INSTALLATION INSTRUCTIONS

Meggitt/Avery Hardoll Hydrant Valves

PVMY1000M1 or PVMY1000M2

PVMY1000M3 Standard

Figure 1: Parts to be replaced from PVMY1000M1 or PVMY1000M2

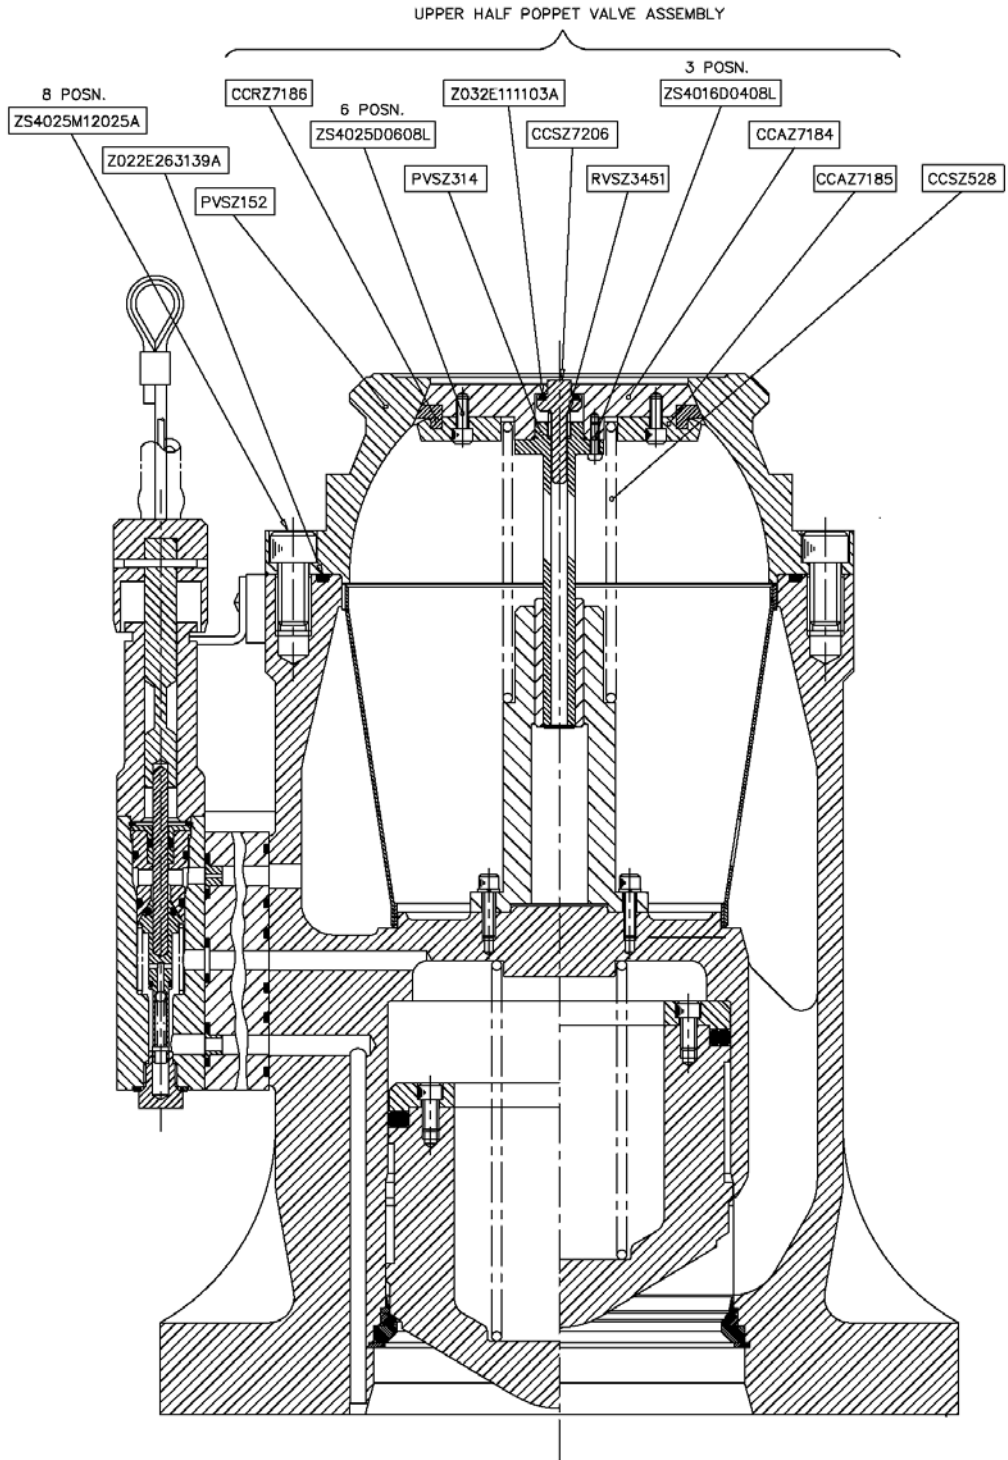
Figure 1 depicts all old components that are to be removed from the PVMY1000M1 or PVMY1000M2 hydrant valve to start the upgrade process. Paragraph 2.1 details the disassembly procedure.

- 2.1.4 Remove upper half API Adapter P/N PVSZ152.

2.1.5 Remove the upper half poppet valve assembly as a whole.

2.1.6 Remove the Compression Spring P/N CCSZ528.

2.1.7 Remove and discard O-ring P/N Z022E263139A.

Figure 2: Parts added to upgrade PVMY1000M1 or PVMY1000M2 to PVMY1000M3 standard

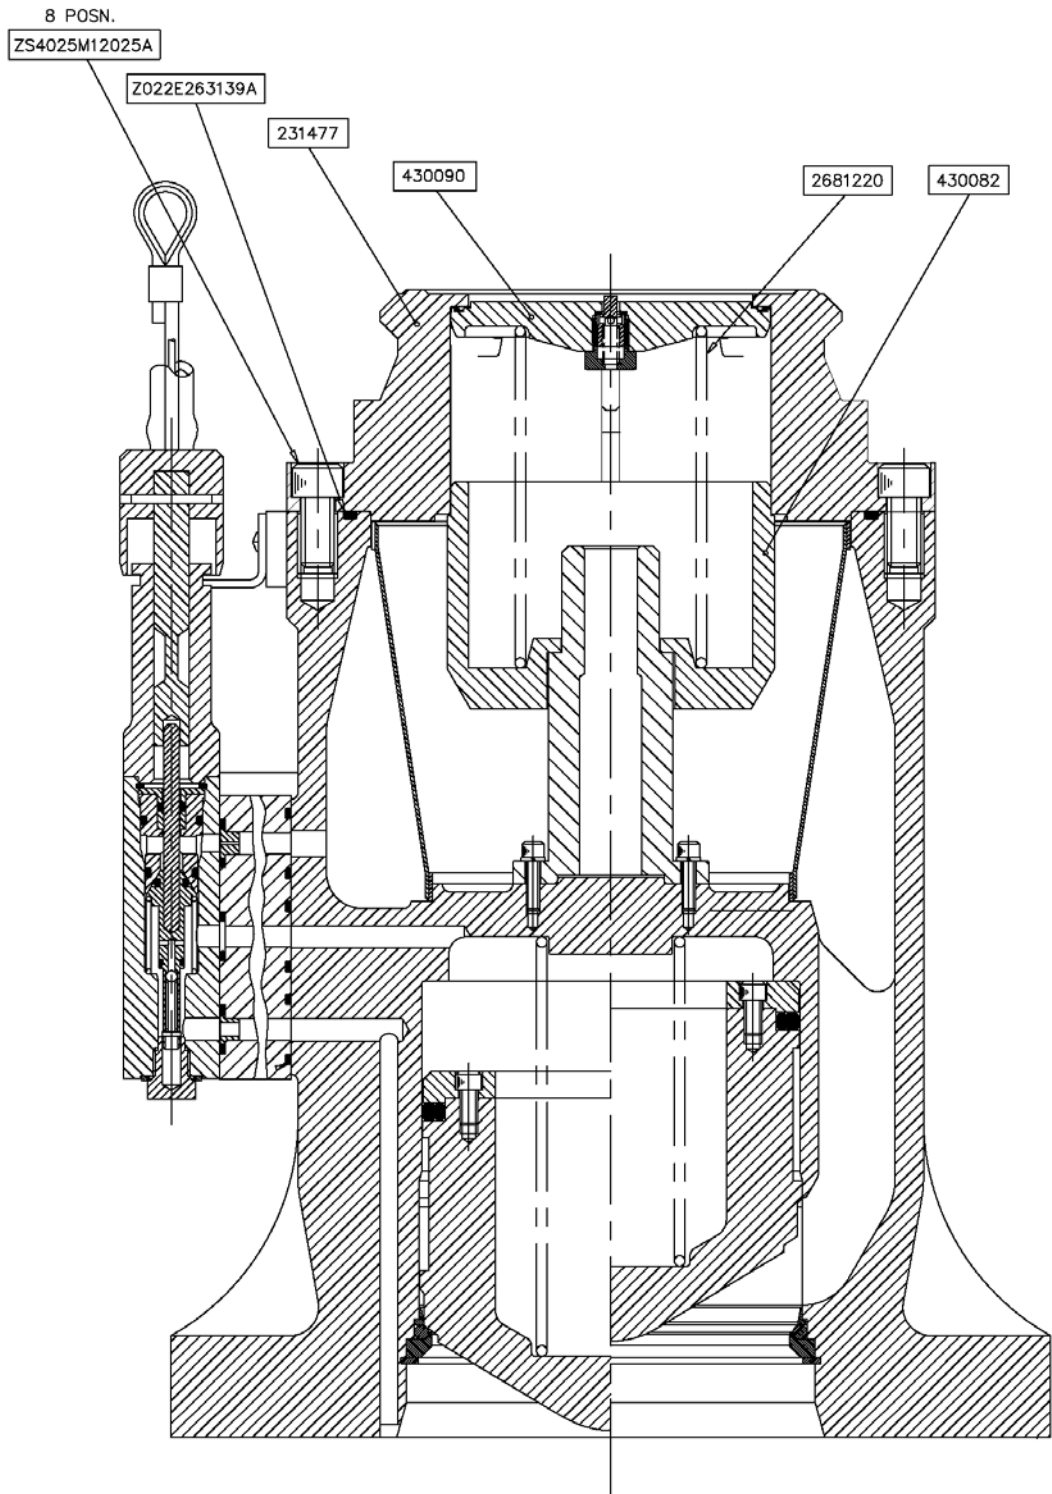
Figure 2 depicts all new components to be installed onto the existing lower hydrant valve half to facilitate upgrade to the PVMY1000M3 standard. Paragraph 2.2 details the re-assembly procedure.

2.2.1 Install the new O-ring P/N Z022E263139A from the upgrade kit to the seal gland in the lower half of the hydrant valve.

2.2.2 Assemble the Inner Chamber P/N 430082 onto the pip valve guide of the lower half.

2.2.3 Place the Poppet Spring P/N 2681220 into the Inner Chamber.

2.2.4 Place the Poppet Assembly P/N 430090 onto the Poppet Spring.

2.2.5 Place the API Adapter P/N 231477 over the Poppet Assembly. Compress the Poppet Spring until the API Adapter engages the hydrant valve lower half.

2.2.6 Use the 8 socket head cap screws P/N ZS4025M12025 to secure the API Adapter against the hydrant valve lower half. Torque the socket head screws at 400 in-lbs.
